# Access Compliance Report

### (Curb Ramps)

Intersection ID: 28787	Main Street: N_ALEXANDER_ST	Cross Street: PARKSIDE_TERRACE_LN	Location: S
ADA ID: 449DD62C2D29	Ramp Type: PerpDiag	Initial Pass/Fail: Fail	Overall Compliance: No
Severity Score: 12.5			
Codes/Mitigation Info/Possible Solution		Field Measurements/Component Compliance

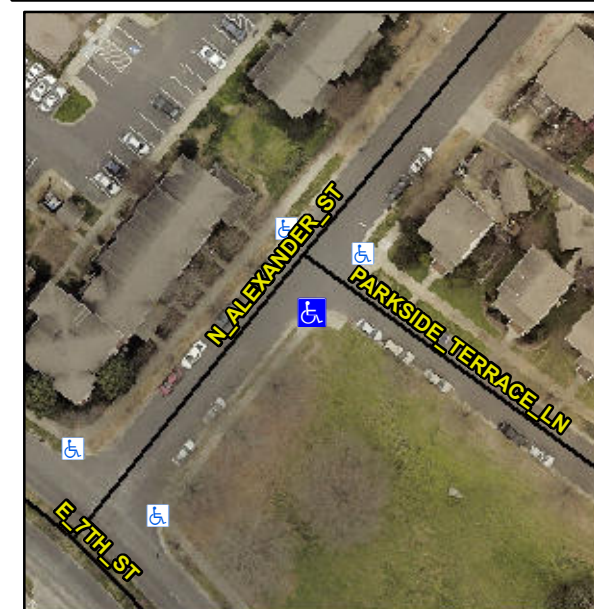
**Not Found, R304.2.2**

Compliance	Description	Data	Compliance	Description	Data
N/A	Ramp Length (in)	73.0	No	Ramp Slope (%)	10.2
Yes	Ramp Width (in)	94.0	Yes	Ramp XSlope (%)	0.5
N/A	Flare Type LT	N/A	N/A	Flare Type RT	N/A
N/A	Flare Slope LT (%)	N/A	N/A	Flare Slope RT (%)	N/A
N/A	Flare Traversable LT?	N/A	N/A	Flare Traversable RT?	N/A
N/A	Landing Length (in)	N/A	N/A	DWS Provided?	N/A
N/A	Landing Width (in)	N/A	N/A	DWS Contrast?	N/A
N/A	Landing Slope (%)	N/A	N/A	DWS Length (in)	N/A
N/A	Landing X Slope (%)	N/A	N/A	DWS Full Width?	N/A
N/A	Landing Curb? (Y/N)	N/A	N/A	DWS Offset (in)	N/A
N/A	Shared Landing?	N/A			
N/A	Gutter Ponding?	N/A	N/A	Gutter Slope (%)	N/A
N/A	Gutter Lip Ht (in)	N/A	N/A	Gutter X Slope (%)	N/A
N/A	Painted X Walk1?	No	N/A	Painted X Walk2?	No
	X Walk 1 Direction	To NE		X Walk 2 Direction	To NW
N/A	X Walk 1 Width (in)	N/A	N/A	X Walk 2 Width (in)	N/A
	X Walk 1 Slope (%)	1.0		X Walk 2 Slope (%)	1.7
	X Walk 1 X Slope (%)	3.5		X Walk 2 X Slope (%)	1.3

**Remove & Replace Curb Ramp With Two New Directional Ramps or Equivalent.**
